Agenda
City of Springboro Planning Commission Meeting
Wednesday, July 9, 2025, 6:00 p.m.
Council Chambers, City Building, 320 West Central Avenue

Background Information & Staff Recommendations
City of Springboro Planning Commission Meeting
Wednesday, July 9, 2025, 6:00 p.m.
Council Chambers, City Building, 320 West Central Avenue

Site Plan Review, south terminus of West Tech Boulevard, new industrial building

C-2.1

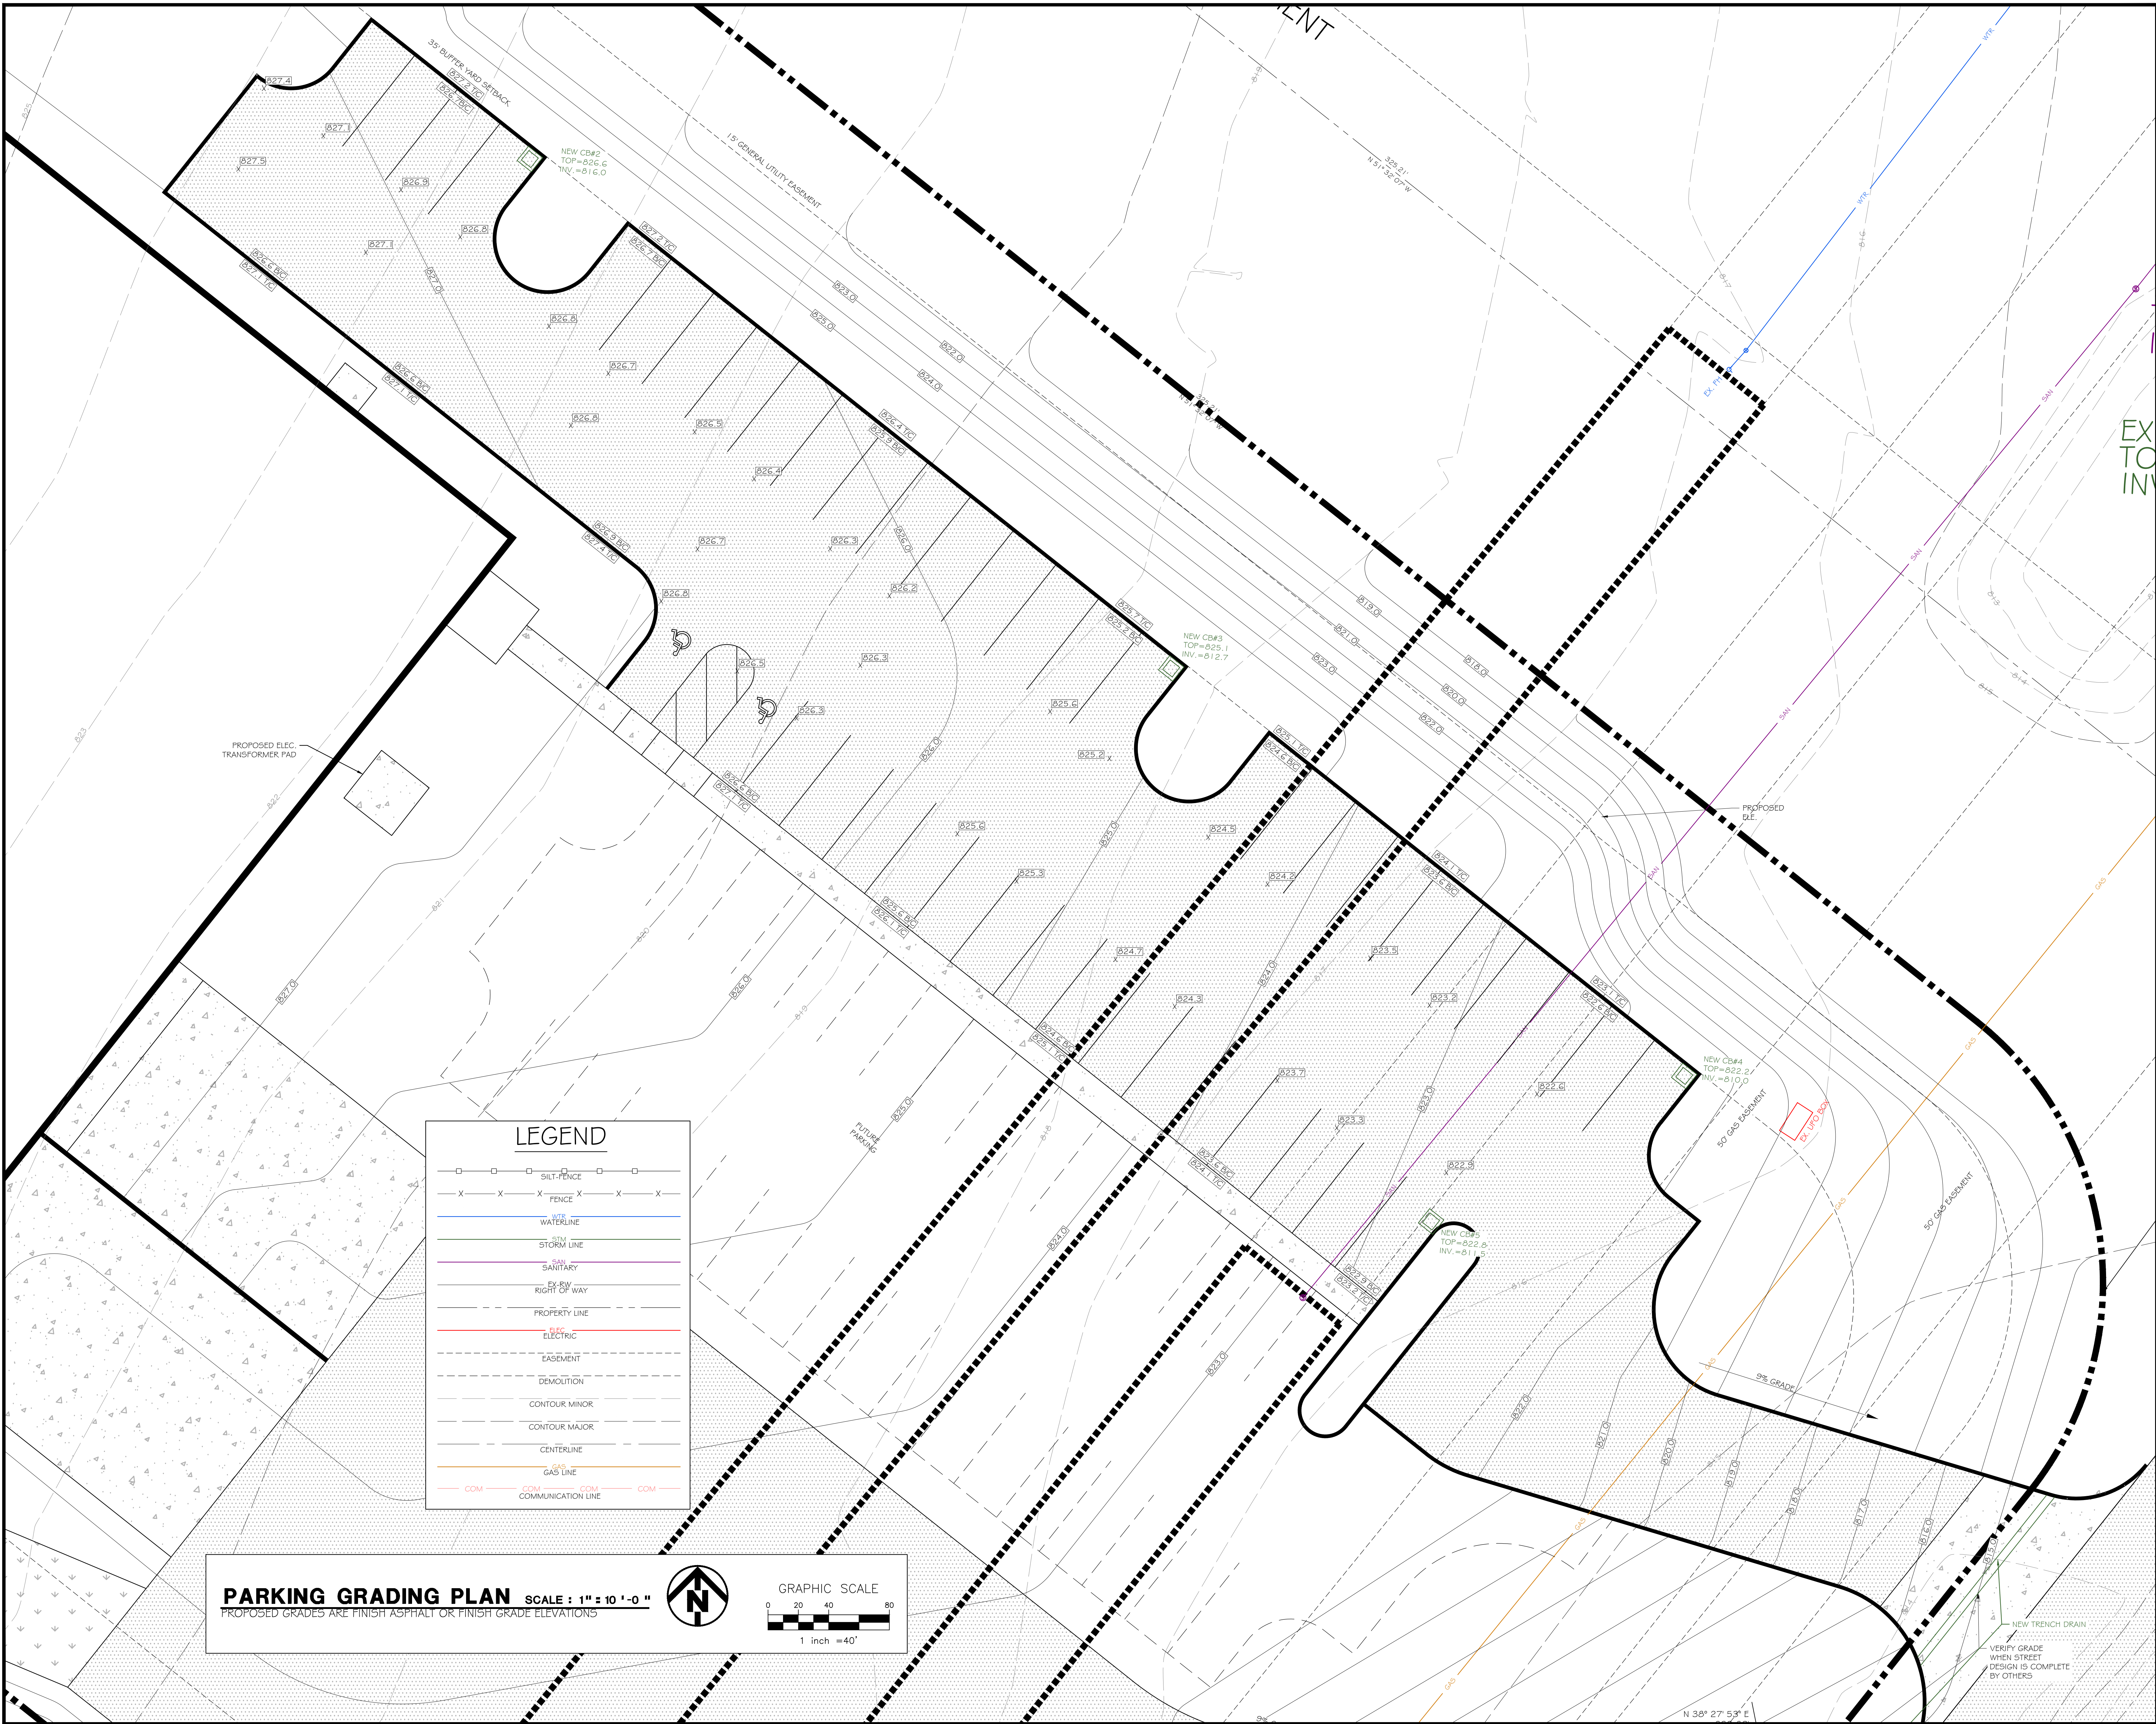
1. Verify color match between north and west elevations.
2. For proposed lighting plan, photometric analysis acceptable. Reduce color-temperature of fixtures to 3500K or less and provide spec sheets for determination of compliance with Chapter 1273, Exterior Lighting, requirements.
3. For landscaping plan, provide 39 trees for site landscaping requirement. May be a combination of shade, evergreen, and ornamentals. Also provide 7 additional trees on I-75 frontage.
4. Coordinate with Zoning Inspector on sign code allowances for buildings in the ADD-1.
5. Water and Sanitary sewer to be reviewed and approved by Montgomery County. Also, revise notes accordingly on C-2.1.

6. Water and Sanitary sewer to be reviewed and approved by Montgomery County. Also, revise notes accordingly on C-2.1. Waterlines to be tested per Montgomery County standards.

LANDSCAPE PLAN

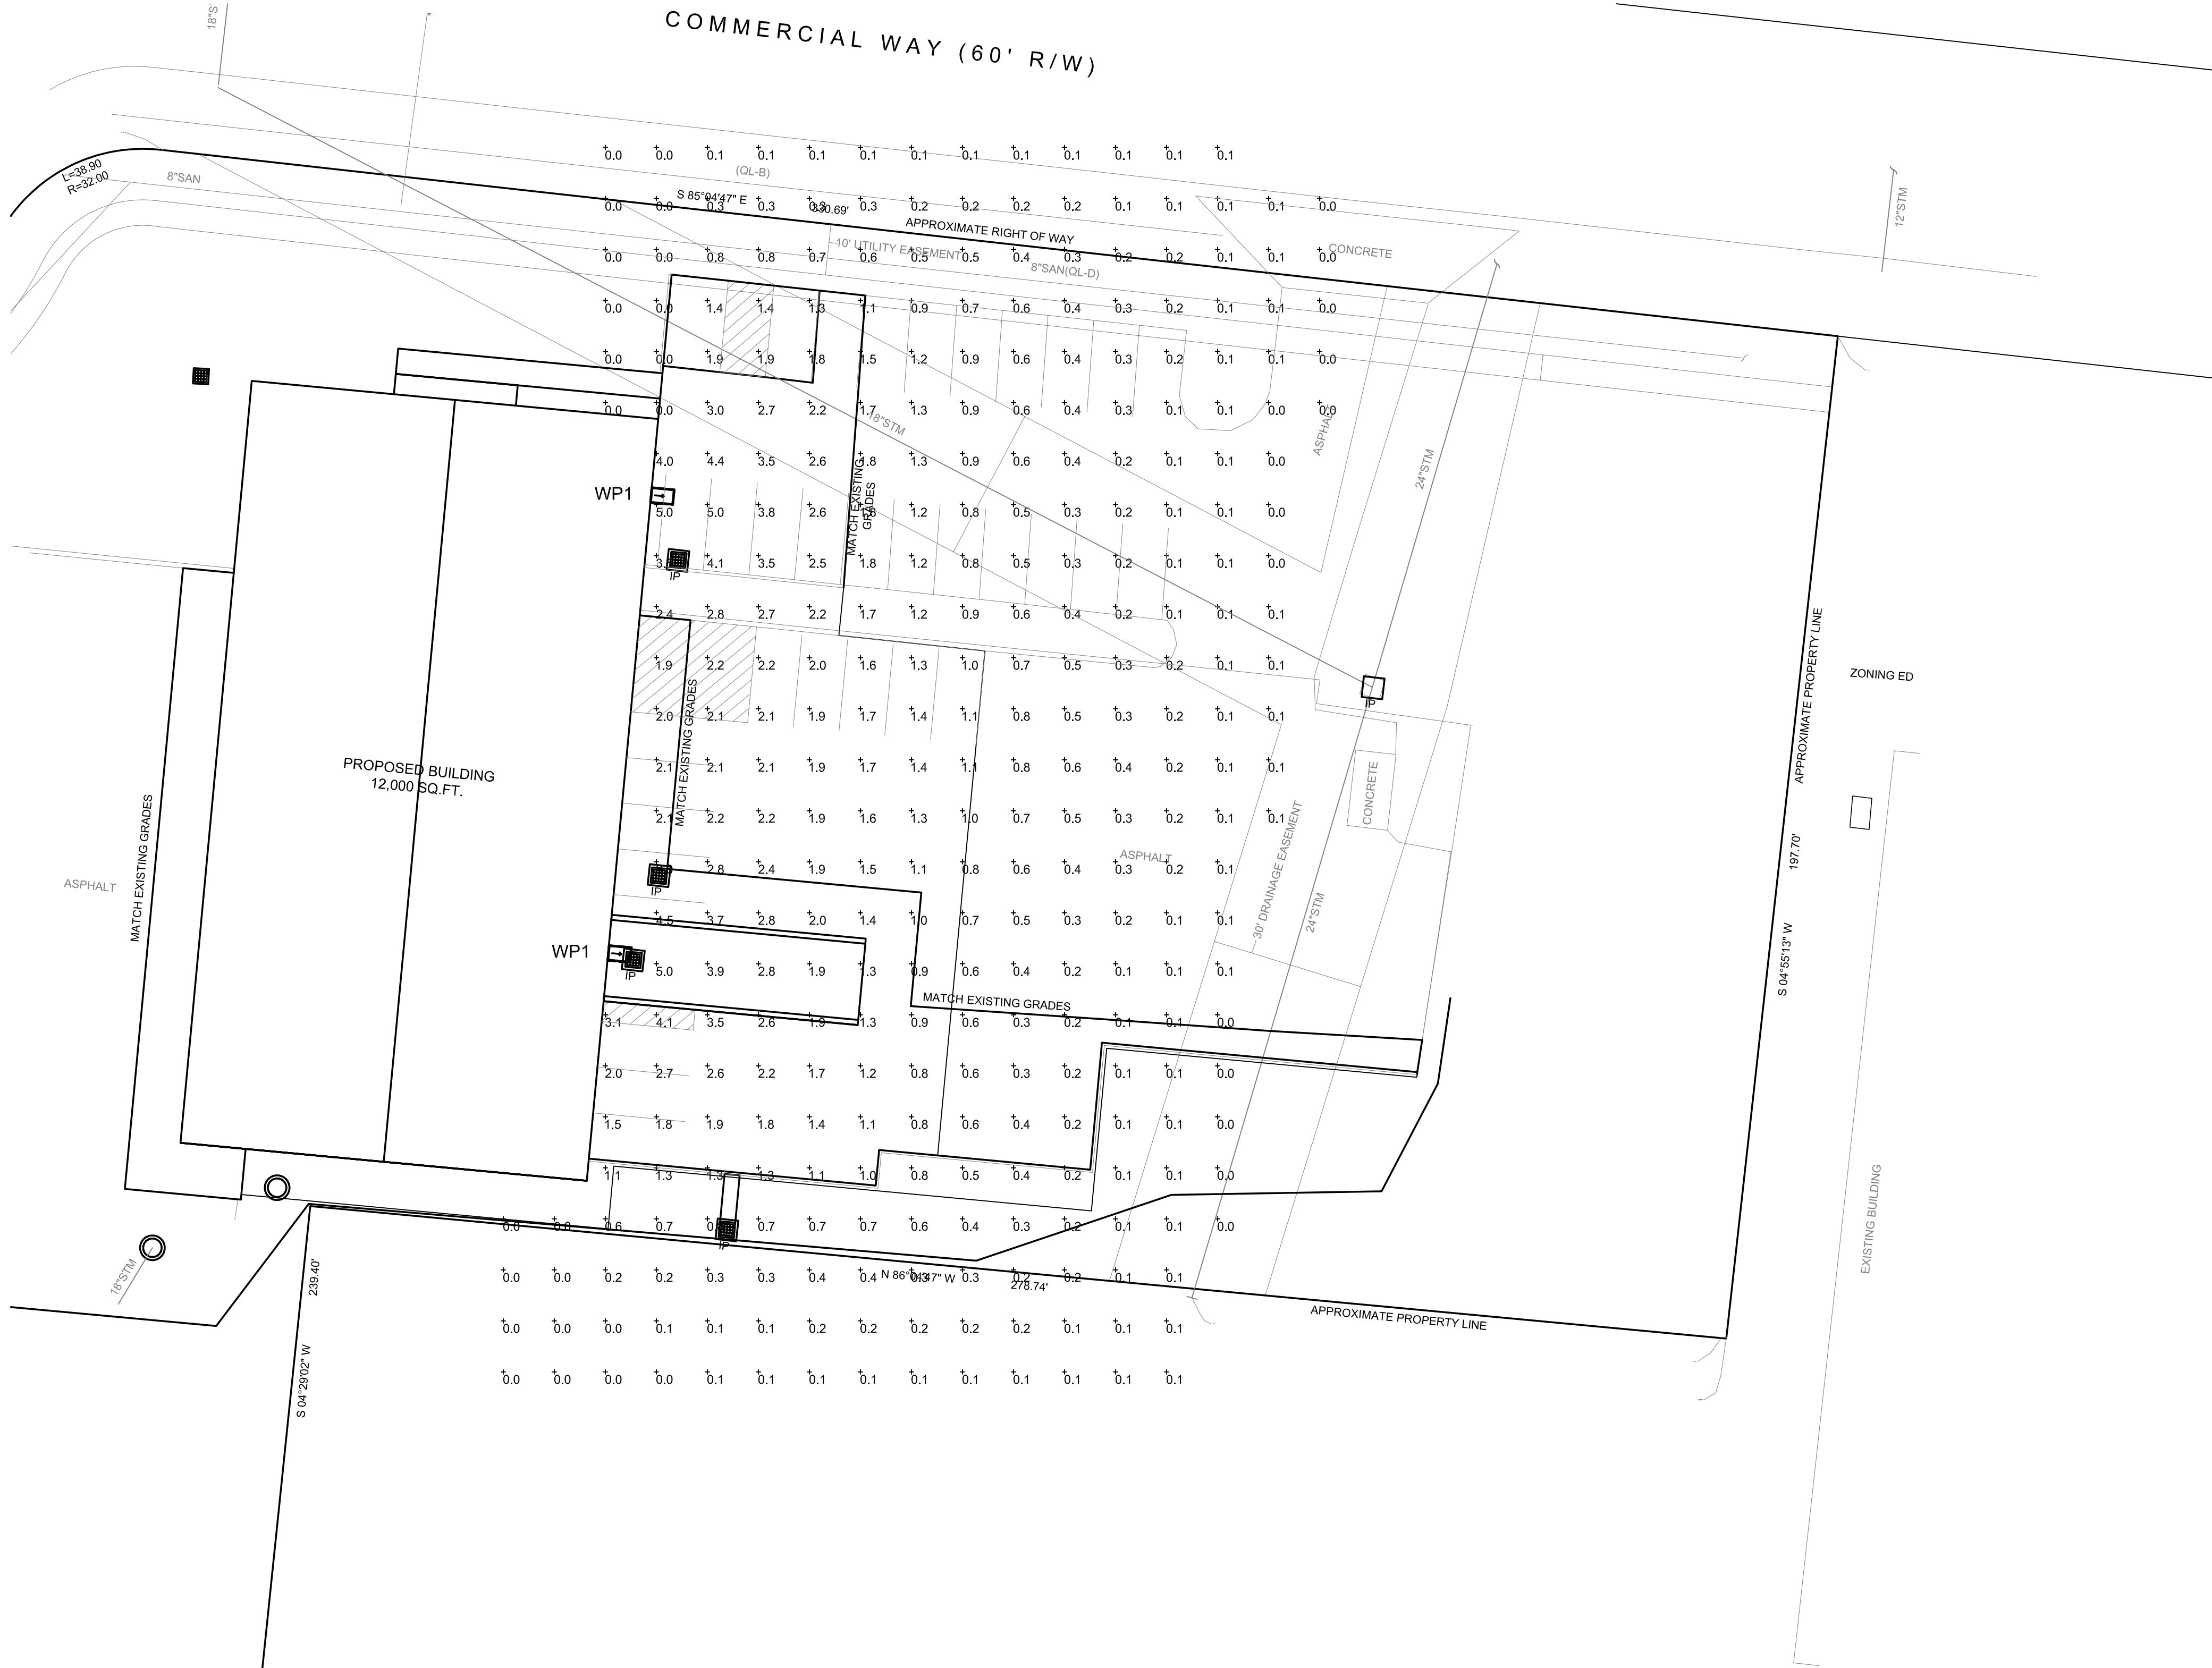
- a. On sheet L1, add 3 ornamental trees on Commercial Way frontage.
 - b. Existing vegetation on east side of site is acceptable for compliance with east and south buffers, and site landscaping requirements.
